STATE OF NORTH CAROLINA  
DEPARTMENT OF TRANSPORTATION

November 12, 2009

SUBJECT: **Permit Modification Request** for High Point East Beltway, US 311 from south of US 29/70 to US 220, Guilford and Randolph Counties, State Project Nos. 8.1570601, Federal Aid Nos. MAF-F-119-1(1), TIP R-0609IA, IB, R-2606A & B, WBS # 34345.1.8

Revised 10/09  
 Permit Drawing  
 Sheet 35 of 74

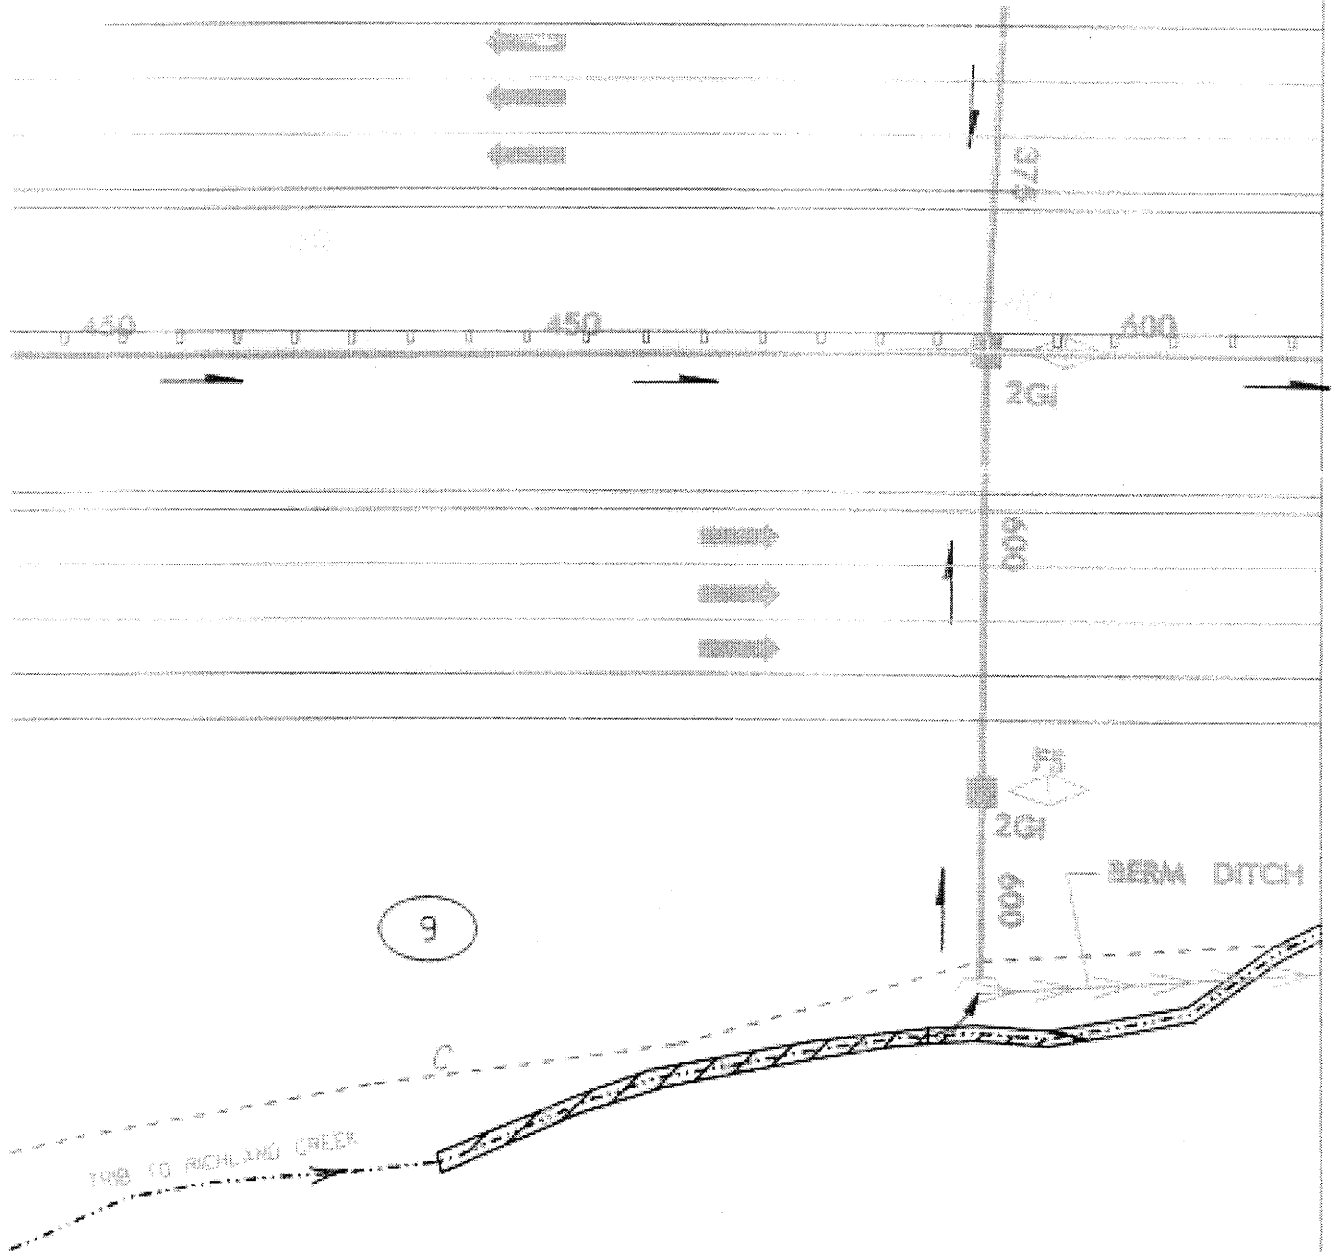
Please find enclosed revised permit drawings for the above referenced project. During project construction, the road bed for US 311 was excavated in order to allow the roadway clearance under Interstate 85. The excavation of the roadbed resulted in lowering of the groundwater table and therefore the adjacent stream lost all ground water flow. The impacts occur at Stream Site 10-Tributary 1 (Buffer Site 8-Tributary 1) within the Cape River Basin (HUC 03030003). The dewatering of the stream increases stream impacts by 109 feet and buffer impacts by 5,645 ft<sup>2</sup> in Zone 1 and 4,078 ft<sup>2</sup> in Zone 2. There will be no changes to impacts to Waters of the US at any other sites.
